Issue Number:	N172404	PDF Date Submitted	01/07/2005		
<input checked="" type="checkbox"/> Part - Location:	Ignition Key Cylinder Assembly -Column - Steering				
<input checked="" type="checkbox"/> Complaint:	vehicle can be keyed off with knee while driving				
Issue Type:	Current Prod	Vehicle/Product Line:	3Acar		Region:
<input checked="" type="checkbox"/> Severity:	3	Primary Metric/Score:	LaunchX / 0.025

Issue Number:	N172404	 Impact
Part - Location:	Ignition Key Cylinder Assembly -Column - Steering

GMX001 Lock Module Detent in RUN

Containment Solution

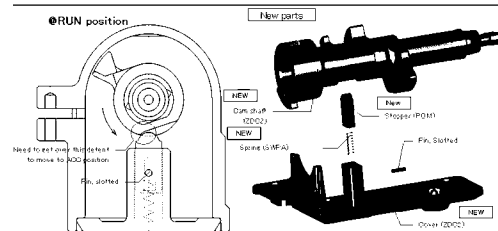
➤ Changing slot in the key in order to reduce lever arm and thus the torque:

✓ It was determined that the lever arm is still present due to fob ring. This may even cause a higher pulling load if fob ring is wedged between the slot and the sharp corner of key.

✓ Can be considered as a containment if the shape of key is changed to round corners
